### TI 1096 – TD3030 lint drawer switch operation

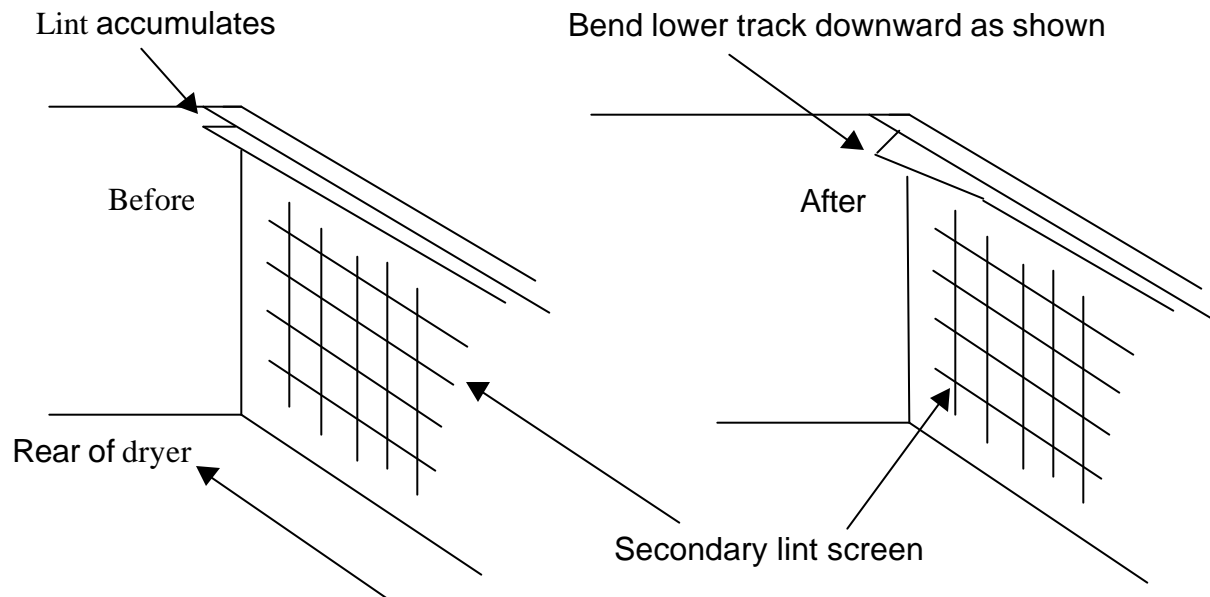
On early model TD3030 dryers, lint accumulation in the lint drawer slide tracks may prevent the lint drawer from closing far enough to activate the lint drawer switch(es). If this occurs, the dryer will not start, and, on some versions, an “E15” airflow error may be displayed.

1. Disconnect electrical power from the dryer
2. Remove the lint drawer from the machine.
3. Use a small screwdriver, or other suitable implement to clean the accumulated and compacted lint from the rear of the drawer tracks in the dryer. CAUTION – wear work gloves! Edges of steel may be sharp!
4. Use the special Track Adjustment Tool, part number 098612 (available on loan from Wascomat) to bend the trailing end of the lint drawer track downward to allow lint to fall out of the track when the drawer is slid into the dryer.
